Responses to the interactive comment on “Validation of the dynamic wake meandering model with respect to loads and power production” by Inga Reinwardt et al., manuscript number: wes-2020-126

Responses to Anonymous Referee #1

Responses to Anonymous Referee #2

Figure A1. Schematic illustration of the flapwise blade root bending moment according to Reinwardt (2017). The aerodynamic force $F_{r,z}$, the gravitational force $F_{g,z}$ as well as the total force F_z perpendicular to the rotor plane at different wake situations are marked.

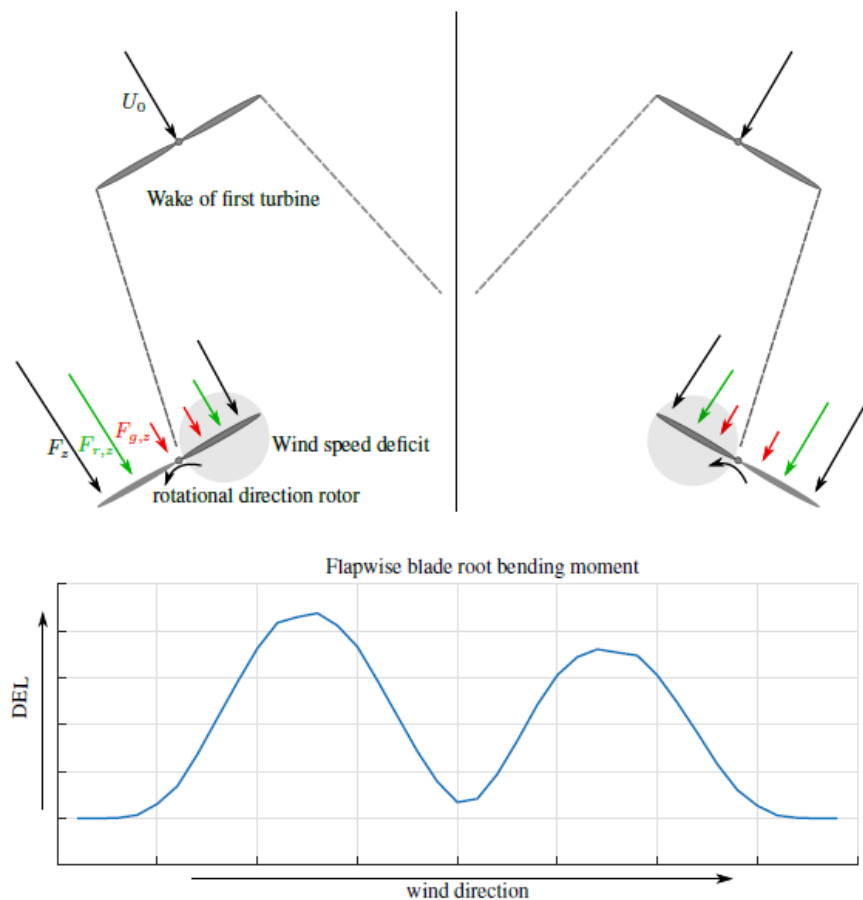
L 297-298: *“Because of the tilt, the blade faces slightly away from the wind direction during the upward movement ... whereas during the downward movement, the blade faces slightly more towards the wind direction”* Not clear to me. Could you clarify, please?

Response: To provide a better explanation of the phenomenon, the following graphical illustration was added to the appendix of the paper.

The explanation of the different pronounced maxima is related to the aerodynamic force and the rotor tilt. The aerodynamic forces on a blade segment are a function of the apparent wind velocity, which is a vector composed of the motion of the blade and the incoming wind. Due to the turbine tilt, the apparent wind velocity is slightly lower during the upward movement, and the aerodynamic force is reduced. The blade faces slightly away from the wind direction during the upward movement, whereas during the downward movement, the blade faces slightly more towards the wind direction, which results in an increase of the aerodynamic force. The aerodynamic force (the green arrow) is higher outside the wake on the left side of the figure than the aerodynamic force on the right side of the figure outside the wake. Similarly, the aerodynamic force in the wake is higher on the right side. At wake conditions, the increase is stronger when the wind speed deficit coincides with the upward movement of the rotor (left side of the figure), so that a higher alternating load at the blade occurs and the maximum is more pronounced in comparison to the case, where the wind speed coincides with the downwind movement of the rotor (right side of the figure).

Figure A2. Schematic illustration of the edgewise blade root bending moment according to Reinwardt (2017). The aerodynamic force $F_{r,y}$, the gravitational force $F_{g,y}$ as well as the total force F_y in the rotor plane at different wake situations are marked.

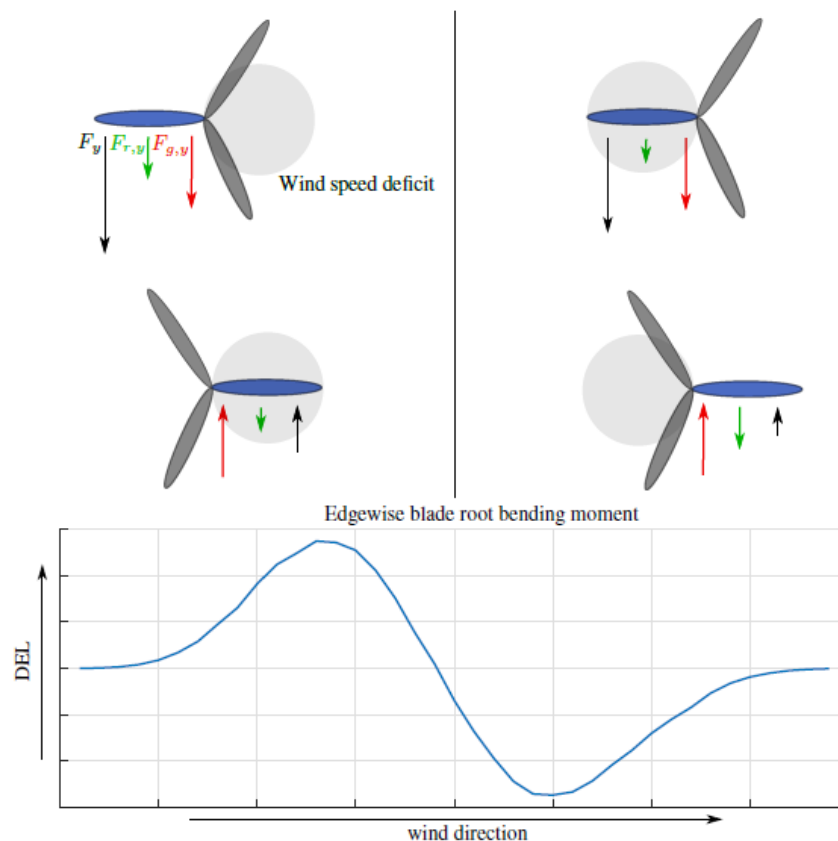
L 311-314: “The load is defined in the rotating frame of reference, so that the weight force switches its sign with each rotation, whereas the influence of the aerodynamic force on the edgewise moment does not change the sign. Thus, at one side of the rotor the forces level each other out, while on the other side of the rotor they accumulate.” The understanding would be eased if you could add a schematic.

Response: To provide a better explanation of the phenomenon, the following graphical illustration of the edgewise moment was added to the appendix of the paper.

The explanation of the curve of the edgewise moment over the wind direction in wake conditions is also related to the influence of the aerodynamic force, which has an influence on the edgewise moment due to the tilt of the rotor and the gravitational force. The edgewise load is defined in the rotating frame of reference, so that the weight force switches its sign with each rotation (see direction of red arrows in the figure inside and outside of the wake), whereas the influence of the aerodynamic force on the edgewise moment does not change the sign (green arrows). Thus, at one side of the rotor the forces level each other out, while on the other side of the rotor they accumulate. If the deficit is on the side where the forces level each other out, the alternating load increases in comparison to a situation without wake, whereas when the wind speed deficit is on the side where both aerodynamic and weight force are facing in the same direction, the alternating load is decreased.
